Elkhart County Jail
26861 County Road 26
Elkhart, Indiana 46516

Location		Structural Inconsistencies		Recommended Corrections/Modifications to Provide Access	Technical Information			Finalized Actions		
Location	Photo	Identified Issue	ADAAG Specification		Priority Ranking and Justification	Improvement Cost	Funding Source	Finalized Correction	Anticipated Date of Completion	Date of Completion

01. Jail Accessible Parking Signage

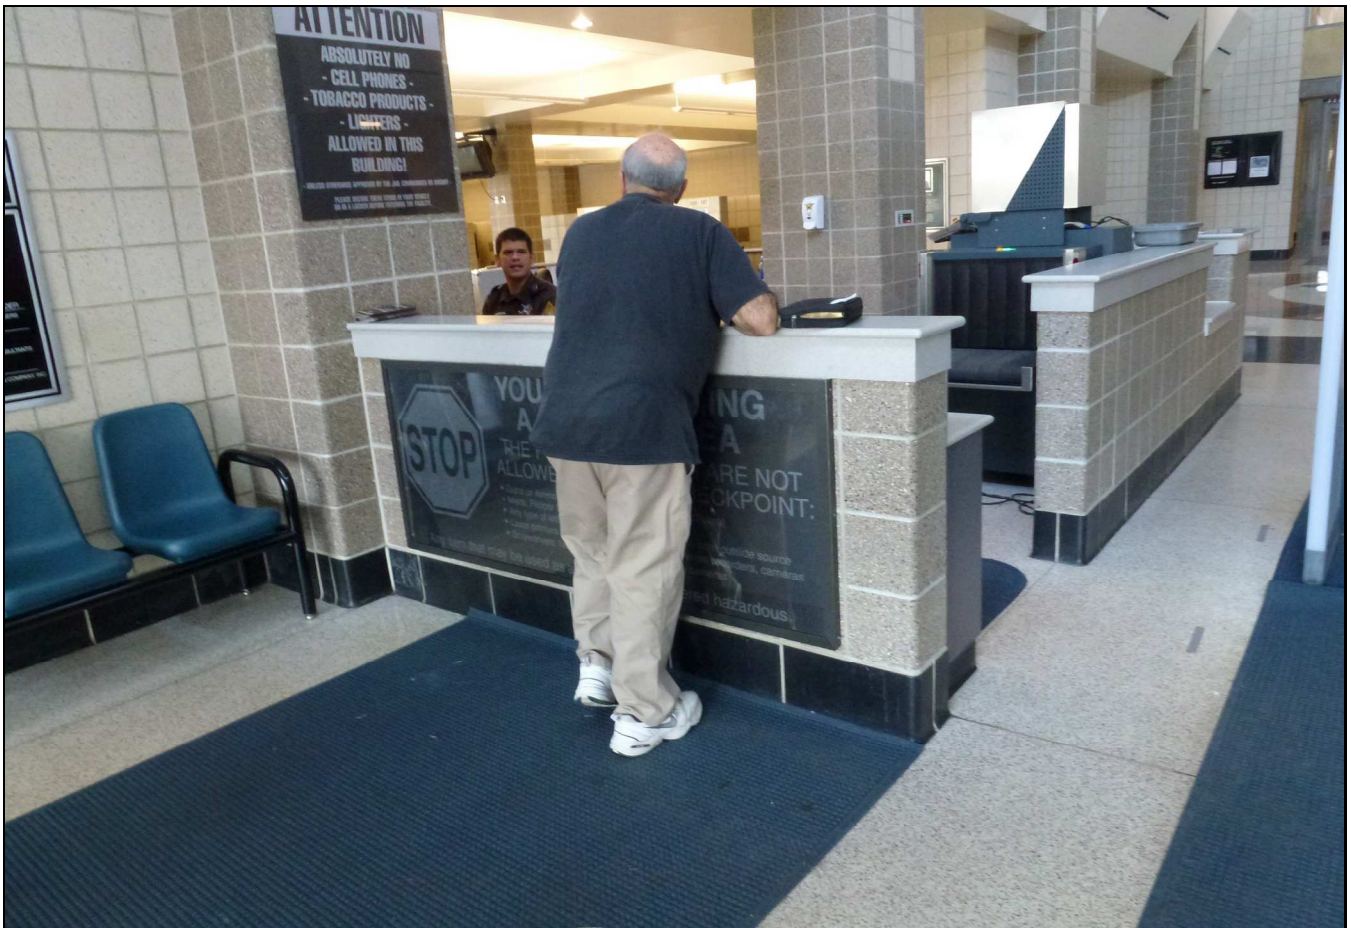
1. Parking	1	No "Van Accessible" sign at van accessible parking space. No enforcement procedure for accessible parking	4.6.4	ADAAG requires accessible parking spaces to be located in each parking lot. Accessible parking spaces are required to have upright signage that includes the symbol of a accessibility and van accessible signage where required. Add one "Van Accessible" sign. Enforce parking regulations.	L: Space is adequate for vans, just no sign posted.	\$125	Elkhart County General Fund	Sign Installed	2012	Jul-12
